# HISTORIC CONSERVATION BOARD AGENDA

Monday, November 7, 2016 at 3:00 pm

## APPLICATION FOR ZONING RELIEF AND CERTIFICATE OF APPROPRIATENESS HISTORIC CONSERVATION BOARD PUBLIC HEARING STAFF REPORT

APPLICATION #:  
APPLICANT: Platte Architects  
OWNER: City of Cincinnati  
ADDRESS: **1611-1613 Pleasant Street**  
PARCELS: 094-0008-0023 and 094-0008-0025  
ZONING: Residential Multi-Family (RM 1.2)  
OVERLAYS: Over the Rhine Historic District  
COMMUNITY: Over the Rhine  
REPORT DATE: October 4, 2016  
HEARING DATE: Prehearing September 14, 2016  
STAFF REVIEW: Beth Johnson, Urban Conservator

**A2-1R**

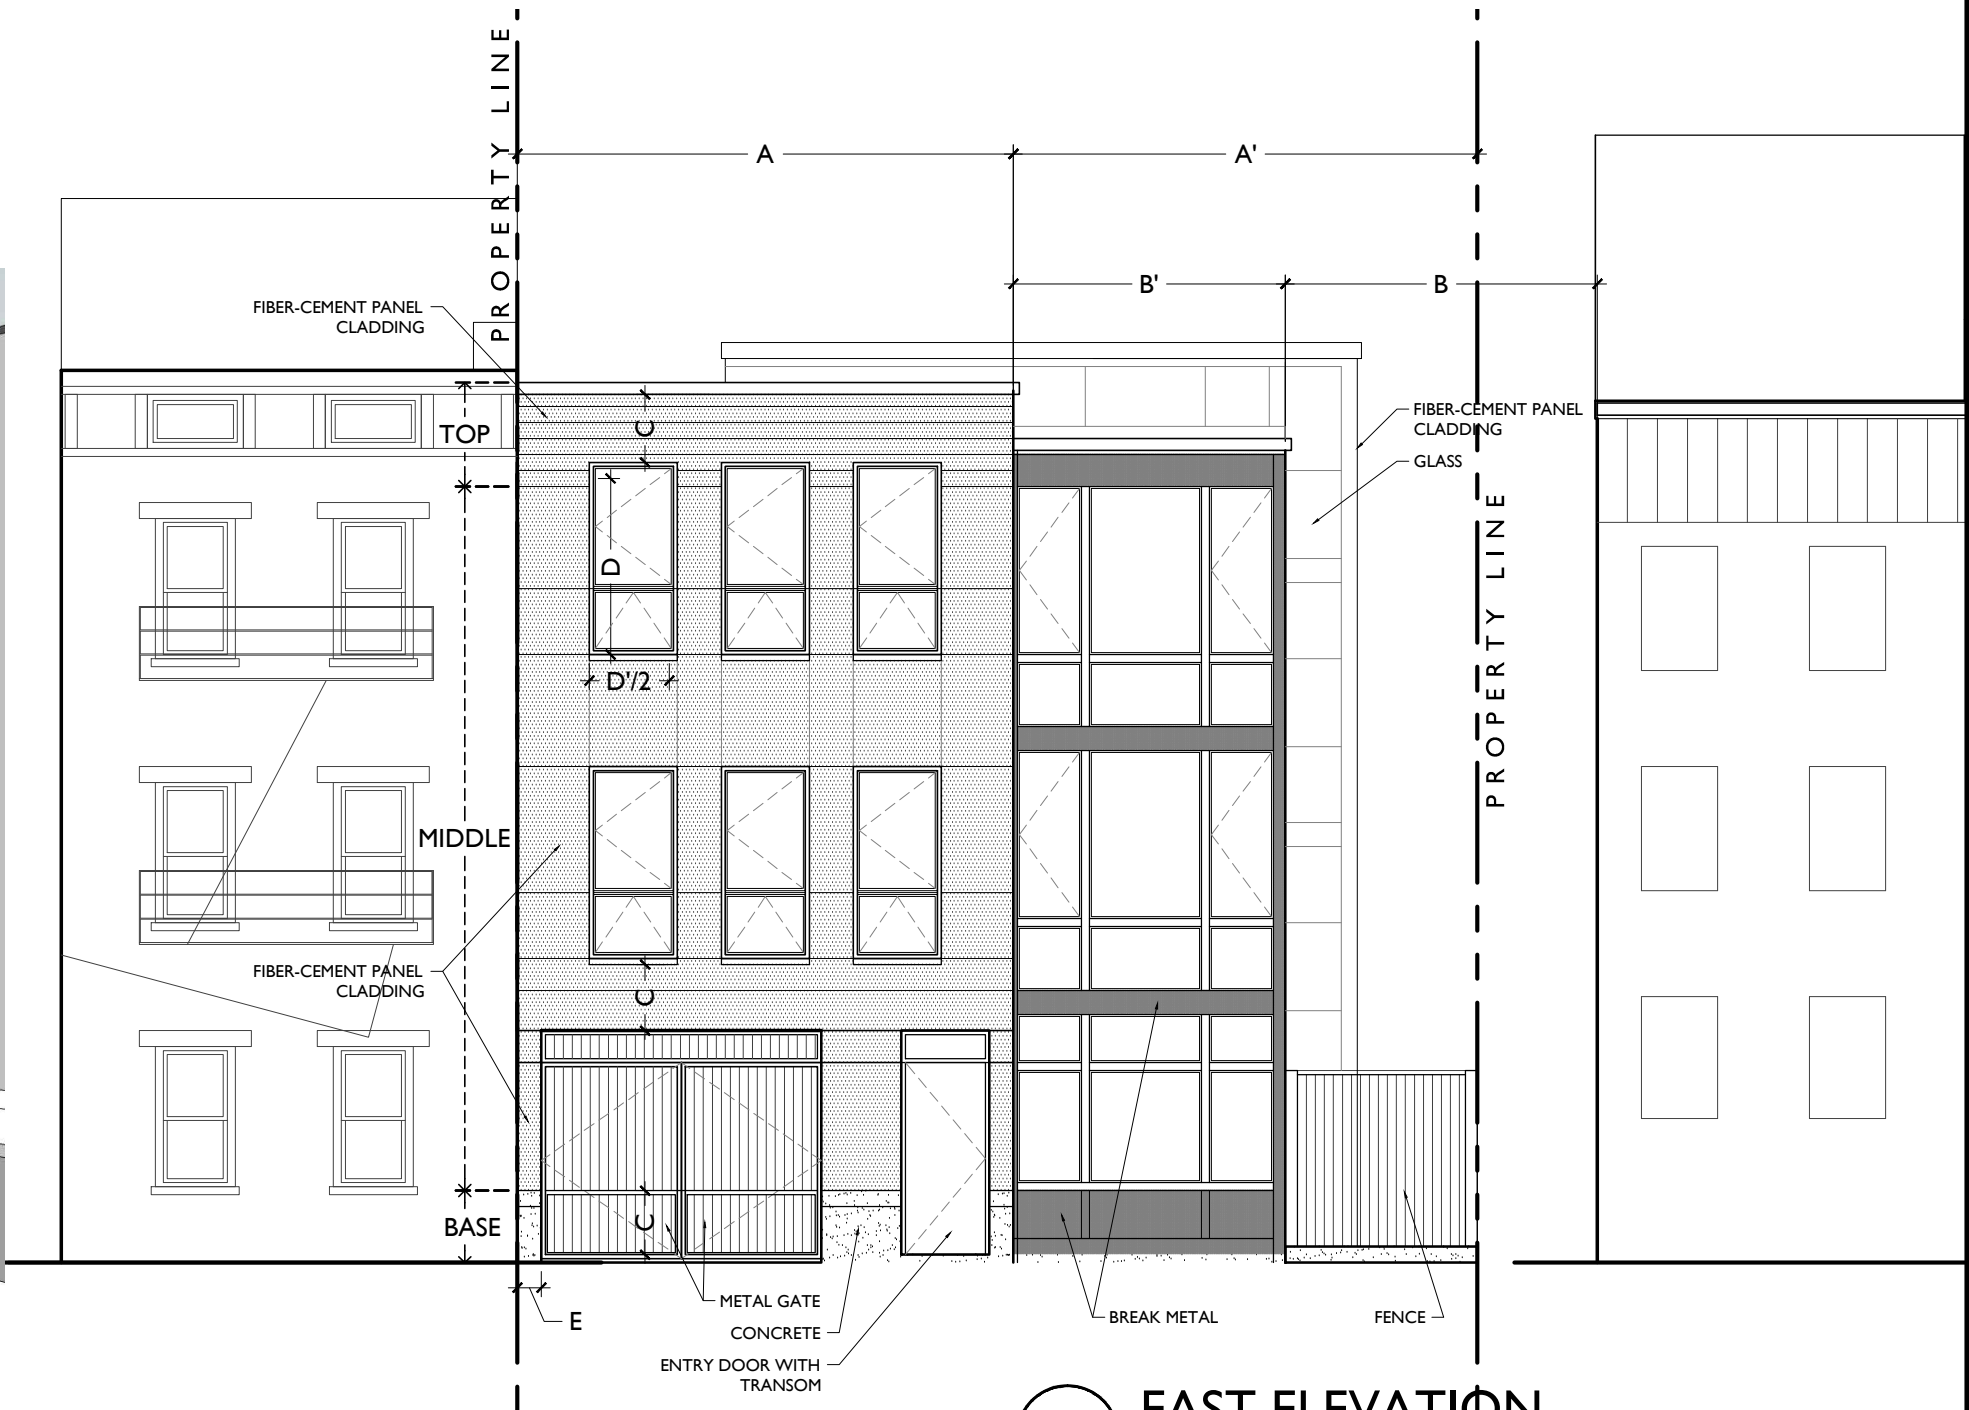
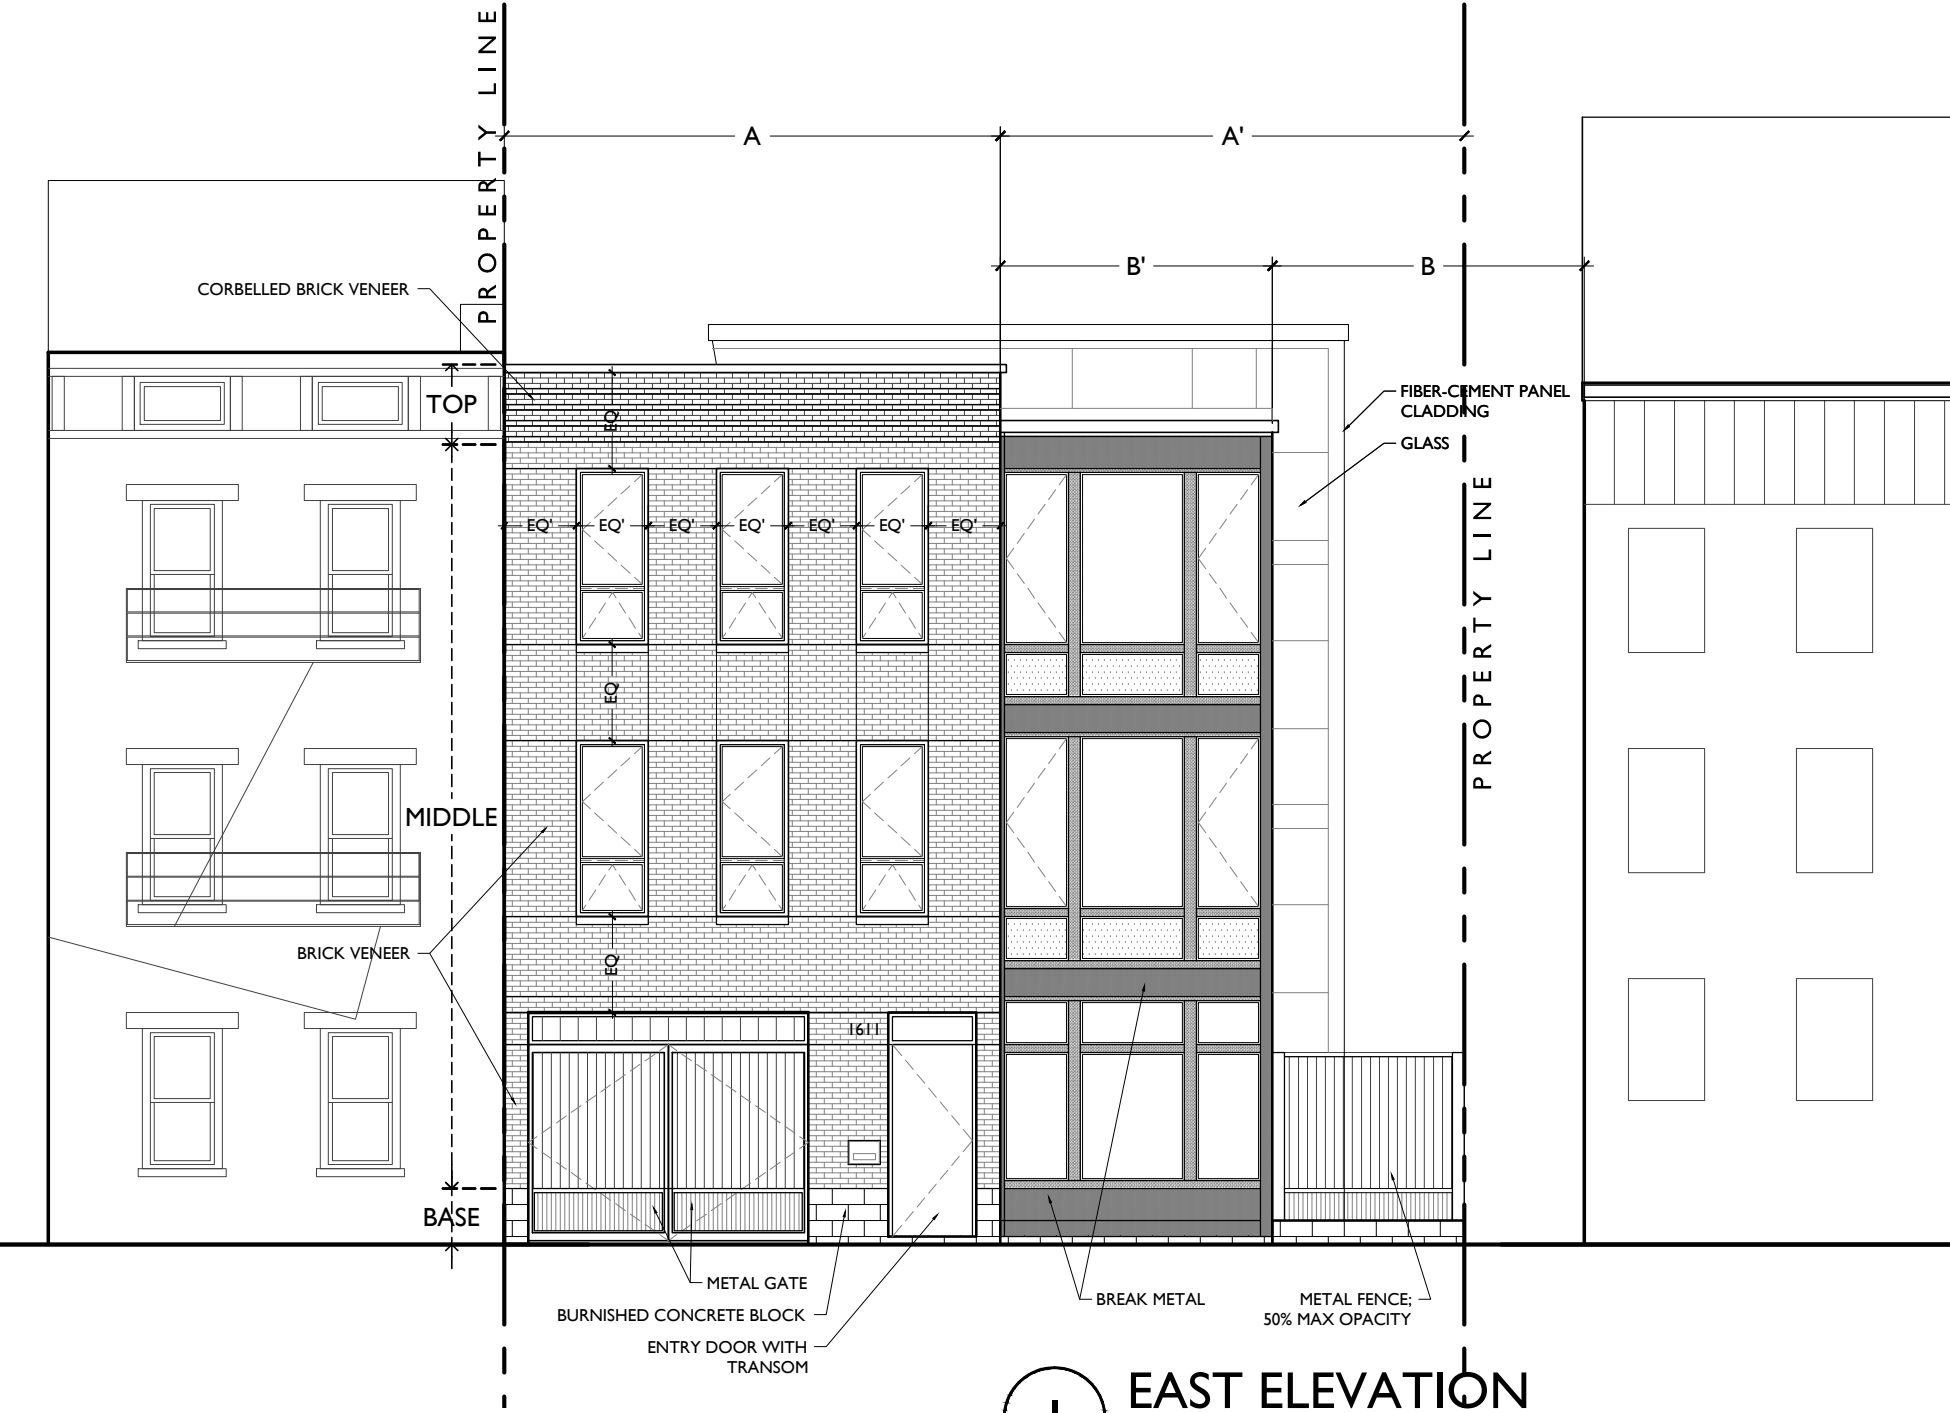
UPDATED DESIGN: At the October 10, 2016 meeting the application was tabled to allow the applicants to address design concerns expressed by the Historic Conservation Board. To address the issues the applicant has done the following:

- 1) The 8 foot fence along the East Elevation is 50% opaque which meets the requirements for zoning.
- 2) The primary street façade will be faced in brick veneer rather than fiber-cement panels.
- 3) The windows and spaces between the windows on the primary façade are the same width which made the spaces between the windows wider.
- 4) The vase of the primary façade is a burnished concrete block rather than just a plain concrete.
- 5) On the secondary façade the vertical divisions between the windows are thicker.

The one outstanding issue and recommendation from staff that was not incorporated was the material on the primary street façade. Staff expressed to the applicant that the most compatible material would be a brick, especially on this section of Pleasant where every building is a brick building. This is one major element that staff does not feel meets the design guidelines and a change to a brick cladding would ensure that the materiality of the streetscape state intact and the building is compatible with its context.

*The 1600 block of Pleasant Street is only comprised of brick buildings and the most appropriate choice of façade cladding would be brick. The applicants have updated their plans to include that the façade will be clad in a brick veneer and will have a corbelled detail at the parapet.*

*i. The dominant volume of the principal (east) façade will be brick veneer. The brick will have a corbelled detail at the parapet to add articulation and shadow lines for added emphasis and interest at the top of the façade. Brick is the dominant material in Over-the-Rhine, and particularly appropriate on this street.*

PROPOSED FRONT ELEVATION OPTION 2

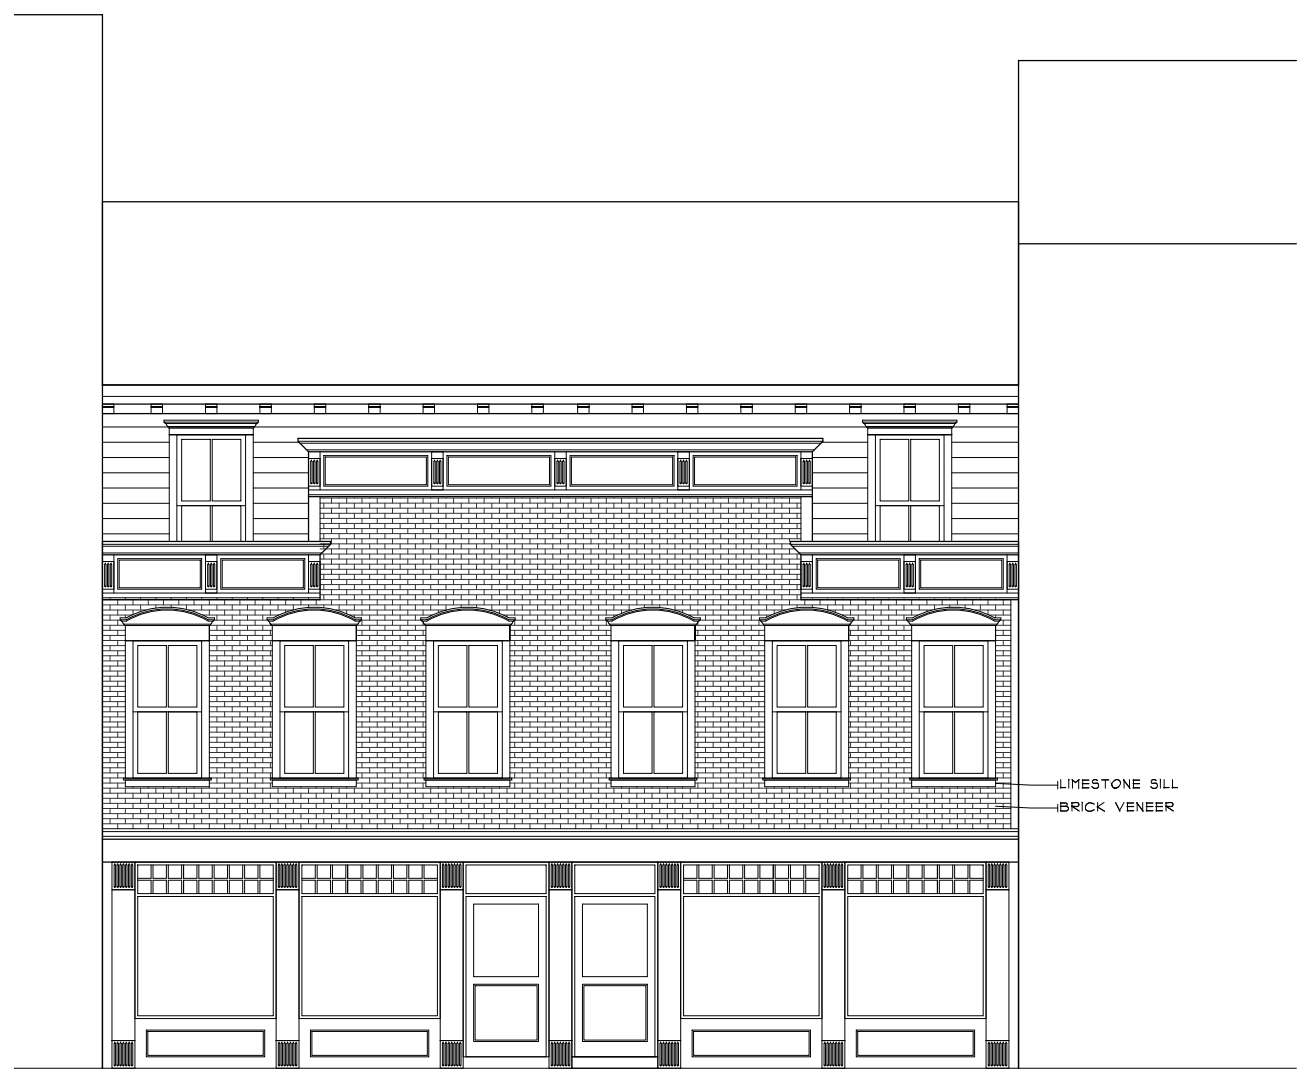
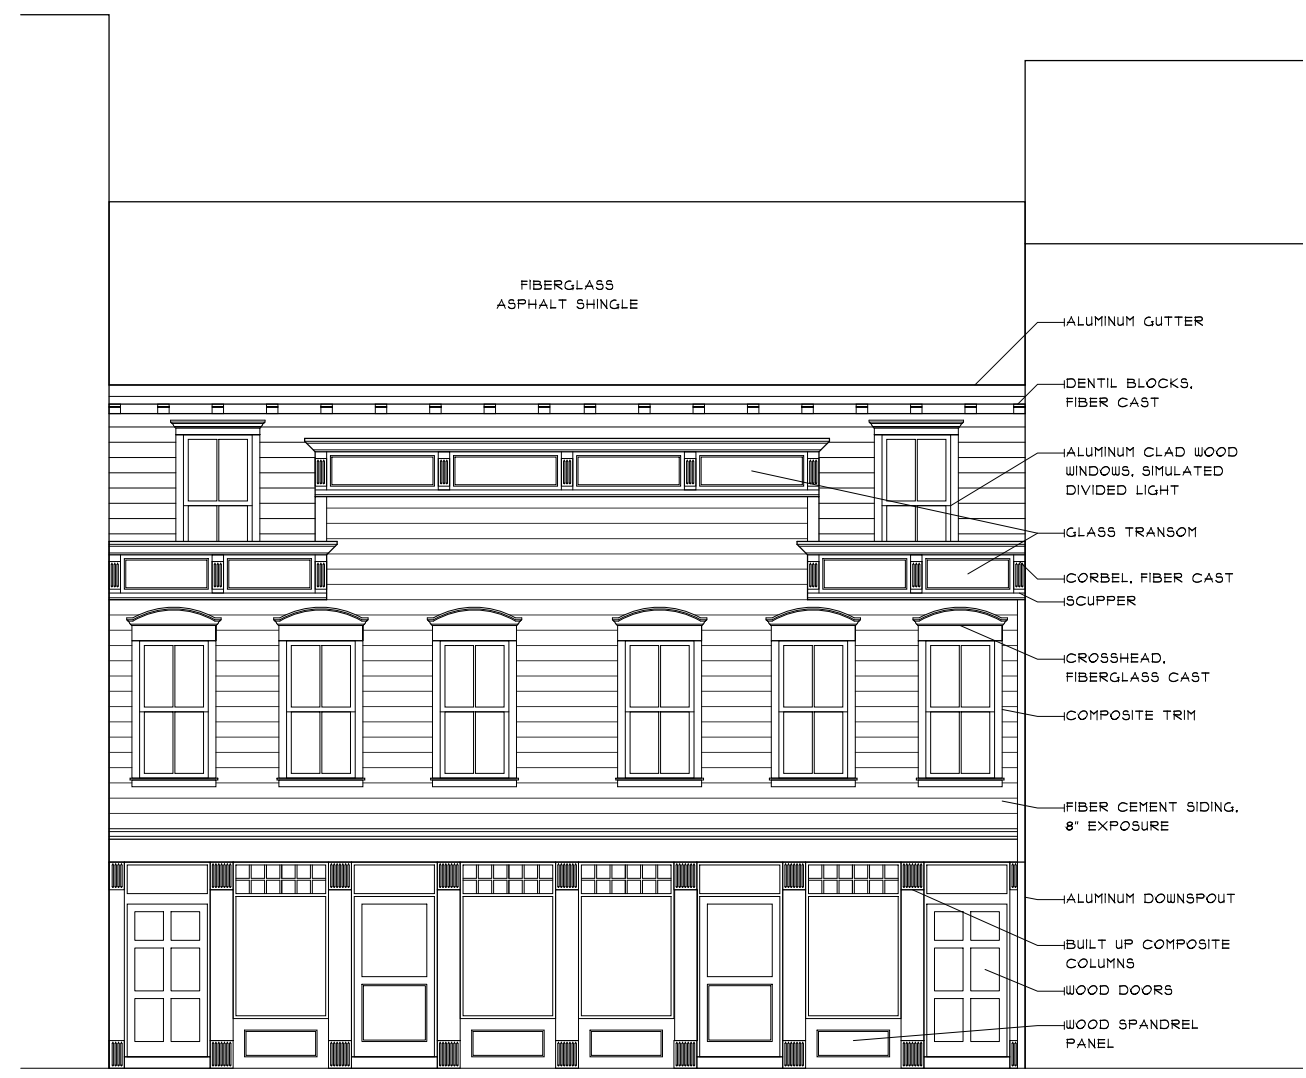
*The subject property will be used as a residence but did traditionally have a storefront. Both designs provide an appropriate storefront design with bulkheads large plate glass storefront glass and a transom. Either option would be an appropriate design.*

1. The second floor of the front façade shall be fiber cement siding with an 8” exposure.
2. The Storefront elevation can be either option proposed in the submitted plans.
3. All wood decking material shall be stained or painted.
4. The curb cut on the alley shall get Department of Transportation Engineering Approval.
5. The building permits must be issued within two years of the decision date or the Certificate of Appropriateness shall expire.
